Table of Contents – Chapter III

Comment III.1(i)	AR-1548, PSNH, pp. 110-111
See also AR-1215, PSNH, p. 169

Figure 4-1. Percent withdrawal versus total number entrained during Merrimack River entrainment studies (2006-2007) (Normandeau 2007b).

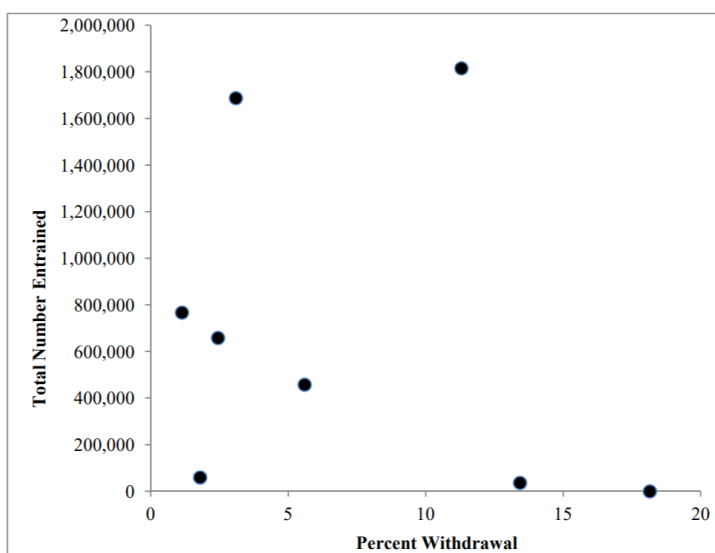
[Responding to AR-618, p. 245 Section 11.2.1a] USEPA provides no evidence for the assertion that eggs and larvae are equally distributed throughout the river. In fact, the peer-reviewed scientific literature indicates that ichthyoplankton have a very patchy spatial and temporal distribution. USEPA provides no basis for its assumption that the percent of water withdrawn for cooling can provide an estimate of the percentage of the ichthyoplankton lost to entrainment. The percentage of the water withdrawn is a factor in determining entrainment, but density of ichthyoplankton in Hooksett Pool over space and time are also important factors. Existing entrainment and withdrawal data do not support the Agency's assumption that entrainment is proportional to percent water withdrawal because the months with the greatest percentage withdrawal are also the months with the lowest ichthyoplankton densities. Figure 4-1 presents a plot of percent withdrawal on the x axis versus total entrainment on the y axis (Table 3-7; Normandeau 2007b). There is no apparent positive relationship between percent withdrawal and total monthly entrainment. In fact, a non-parametric Spearman Rank Correlation analysis indicates that there is a negative relationship (-0.41) between percent withdrawal and total monthly entrainment. The raw data are presented in Table 4-1. The months with the greatest percent withdrawal, August and September 2006, also have the lowest entrainment because ichthyoplankton are not common in Hooksett Pool during those months. The highest entrainment occurred in June of 2006 and 2007 when percent withdrawal was relatively low (June 2006), or

above average (June 2007) but entrainment was highest due to the high density of ichthyoplankton in Hooksett Pool. The conclusion to be drawn from this analysis of empirical data is that percent water withdrawal alone is not a major factor in determining entrainment at Merrimack Station. Density of ichthyoplankton in Hooksett Pool is also an important factor and the greatest percent withdrawals occur in the months when ichthyoplankton density is low. It can be seen that during May, low ichthyoplankton densities are the norm, and that the entrainment estimate for May at Unit 2 is driven by the relatively large amount of ichthyoplankton collected on the night of 31 May (Table 4-2). The data from the night of 31 May might be considered the outlier rather than the 0 counts at Unit 1, but Normandeau included all data in the analysis because there are no methodological reasons to exclude them. Empirical data should not be excluded because it appears to be “different,” but may only be excluded if there is some methodological reason that would justify the exclusion, such as abnormal field sample collection or mishap during laboratory analysis. These incidents did not occur. Therefore, USEPA’s rationale for excluding the data for Unit 1 from May, and substituting the Unit 2 data for the Unit 1 data is not valid. Normandeau’s data estimated 3.2 million larvae per year were entrained, and USEPA improperly changed this number to 3.8 million larvae entrained.
